CITY PLAN COMMISSION**THURSDAY, NOVEMBER 3, 2022****FILE NUMBER:** S223-004**SENIOR PLANNER:** Mohammad H. Bordbar**LOCATION:** Creek Drive at Oxford Drive, north corner**DATE FILED:** October 5, 2022**ZONING:** PD 765**PD LINK:** <https://dallascityhall.com/departments/city-attorney/Articles/PDF/Article%20765.pdf>**CITY COUNCIL DISTRICT:** 12 **SIZE OF REQUEST:** 7.828-acres **MAPSCO:** 5C**APPLICANT/OWNER:** Plano Independent School District

REQUEST: An application to replat a 7.828-acre tract of land containing all of Lots 6 through 10 in City Block 1/8728, all of Lots 12 through 18 in City Block J/8728 and part of Lot 1A in City Block J/8728 to create one lot on property located on Creek Drive at Oxford Drive, north corner.

STAFF RECOMMENDATION: The request complies with the requirements of PD 765; therefore, staff recommends approval of the request subject to compliance with the following conditions:

SHEET 2 OF 2

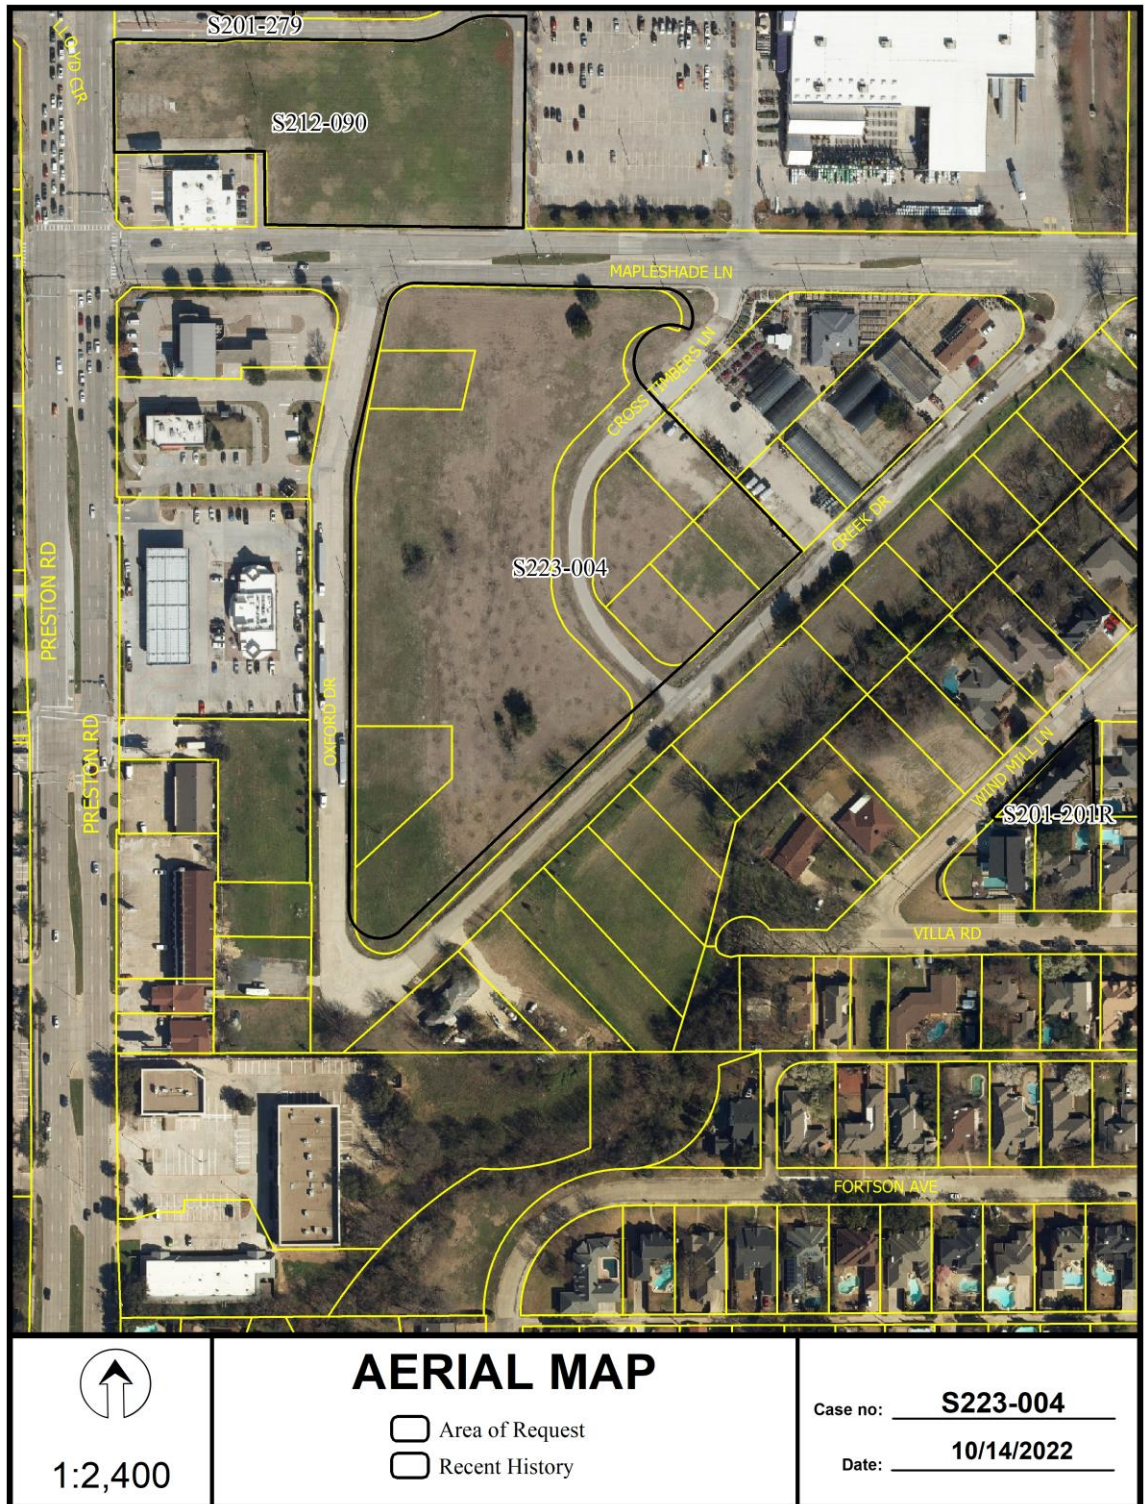
31. On the final plat, use standard language for 10' Easement abandonment noted on the plat as follows: "Abandonment authorized by Ordinance No._____, recorded as Inst. No._____. Contact Real Estate and advise if the language noted on the

plat 10' Sidewalk Easement, 20' Wastewater Easement and Water Easement by this plat is a dedication or an abandonment.

32. On the final plat, change "Mapleshade Lane" to "Mapleshade lane (F.K.A. Brandywine Lane)". Section 51A-8.403(a)(1)(A)(xii)
33. On the final plat, identify the property as Lot 1B in City Block J/8728. Ordinance 1A, Page 131 pages 131-148, Section 2 (passed August 13, 1872).
